RECEIVED JAN 30 2013 SUNDURY NOTICES AND REPORTS ON WELLS

5. Lease Serial No. NMNM 81586
6. If Indian, Allottee or Tribe Name
7. If Unit or CA/Agreement, Name and/or No.
8. Well Name and No. Cedar Canyon 23 #1H
9. API Well No. 30-015-40667
10. Field and Pool, or Exploratory Area Corral Draw Bone Springs
11. County or Parish, State Eddy NM

Attachment 3160-5
 OXY USA Inc.
 Cedar Canyon 23 #1H
 API No. 30-015-40667

Conditions of Approval

6.0 WELLBORE DIAGRAM

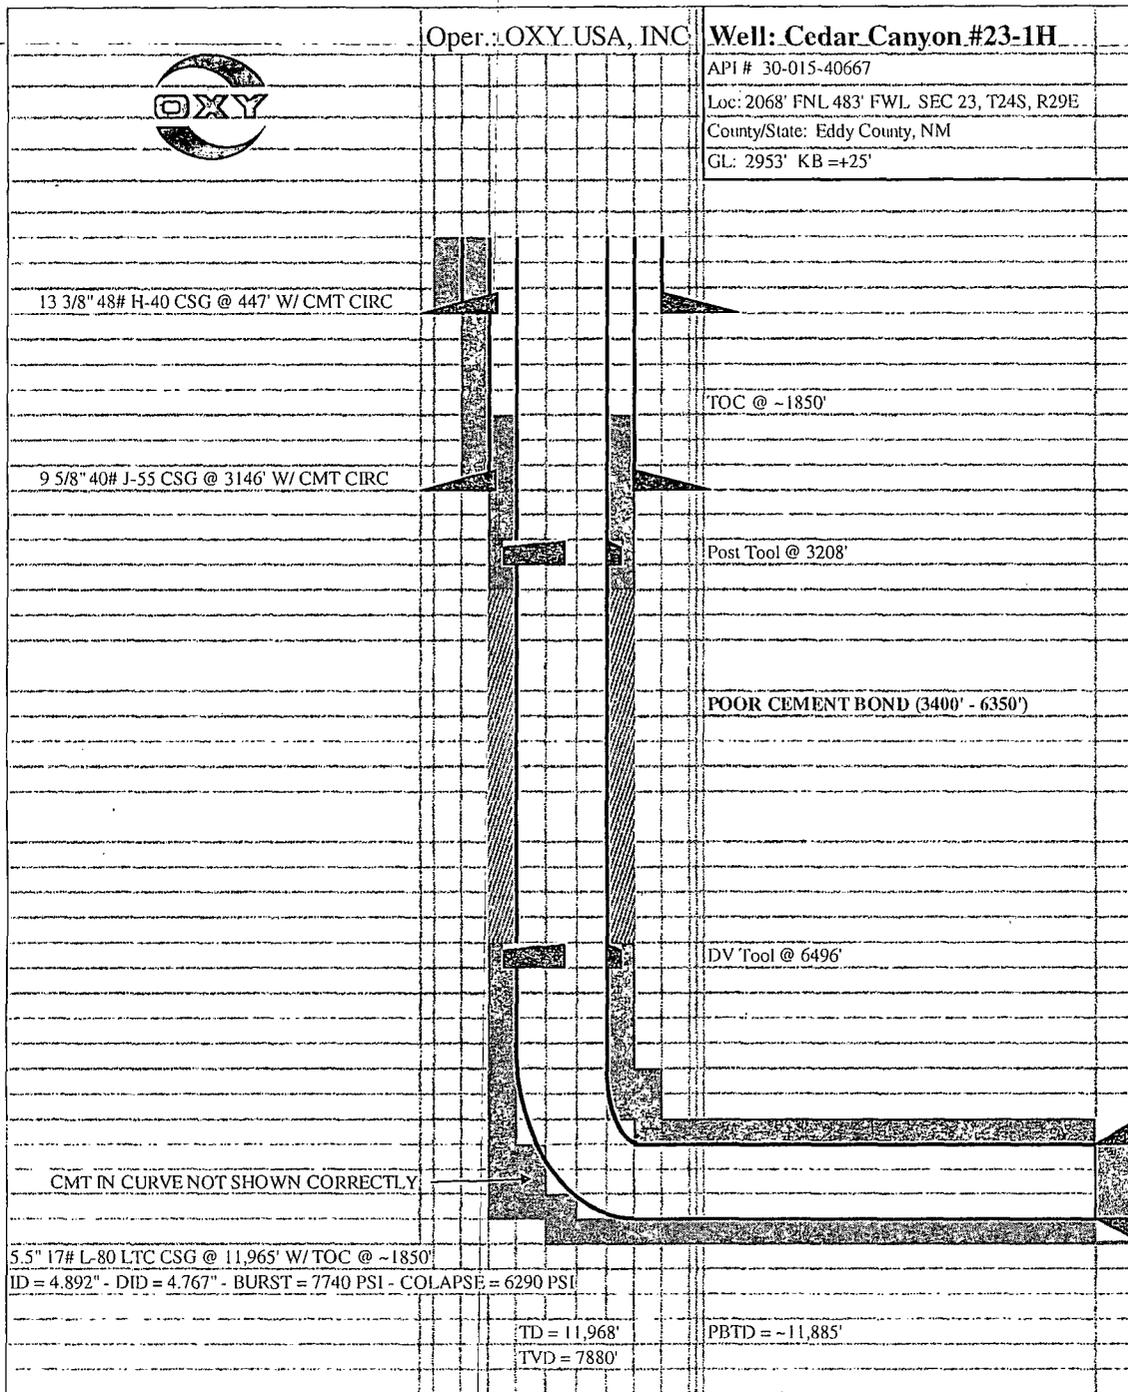
OXY USA Inc. respectfully requests a variance from the agreed APD cementing program due to circulation problems encountered during the cementing process that have resulted in a section of poor cement bond behind the 5-1/2" casing. This can be clearly observed on the CBL, copy submitted 12/17/12. The risk of hydrocarbon migration as a result of the section of poor bond is therefore seen as minimal, thus no cement remediation is proposed for this well.

Excellent cement bond is observed over the reservoir (1st Bone Spring Sand) up to the DV Tool @ 6496' (~1500ft TVD above reservoir) thus sufficient reservoir isolation is thought to be achieved. Good cement bond is also present above the Post Tool (3205' TVD) up to ~1850' (~1350ft TVD above the 9-5/8" casing shoe), therefore the intermediate shoe is also sufficiently isolated.

Cement returns were lost during the 5-1/2" cement job. Drilling Engineer advised that both DV and Post Tool functioned correctly and are closed. GBL indicates no cement bond between the DV and Post Tool. Good cement bond over the reservoir interval and up to 6410ft. Indicates ~1800ft of good cement above the reservoir and thus isolation looks sufficient.

1. **No witness will be required for the Broden head pressure test. The records shall be submitted and maintained for future use.**
2. **A plan for remedial work on the 5 ½" casing (due to insufficient cement circulation) shall be submitted to the BLM within 30 days of frac completion.**

- 1. No witness will be required for the Braden head pressure test. These test records shall be maintained for submittal to the BLM if requested.**
- 2. Operator shall submit a plan for BLM approval for monitoring the annulus during the life of the well.**
